Grand Parkway SH 99 Segment B1 Project Details: Alignment Shift

SH 99 Segment B1 From I 45 to North of FM 2403 and SH 35 from N Gordon Street/BS 35-C to Steele Road

October 12 & 17, 2023

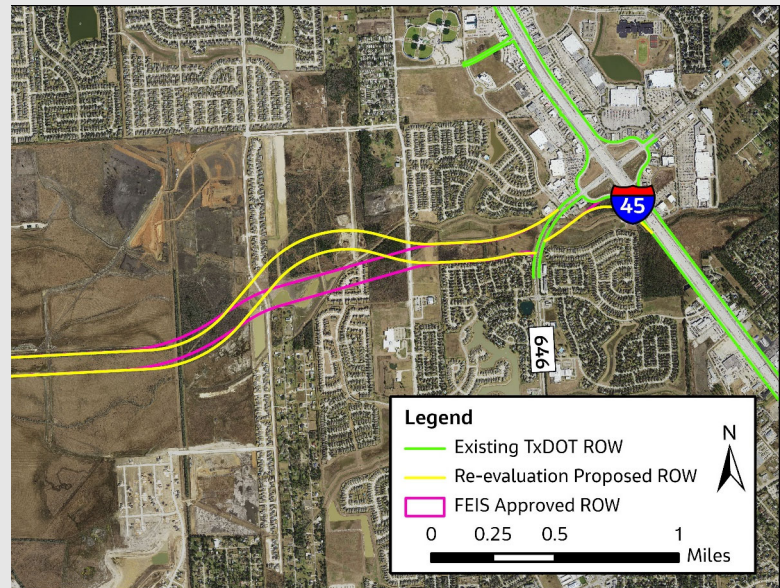
- An alignment shift between Calder Road and Hobbs Road was needed to avoid 26 recently constructed homes that were built within the approved FEIS/ROD preferred alignment.
- Alignment shift north would require 35 acres of additional right-of-way and effect 1 property not previously impacted.

There is a proposed alignment shift between Calder Road and Hobbs Road to avoid 26 new homes in the Bay Colony West subdivision that were constructed within the approved FEIS/ROD preferred alignment. The alignment would be shifted to the north along an alignment reviewed in the Draft EIS. This shift to the north to the Draft EIS alignment would require a re-evaluation of approximately 35 acres of right-of-way that was not in the FEIS/ROD approved alignment and would impact one property that was not previously impacted. There would be no additional displacements as a result of the proposed alignment shift.
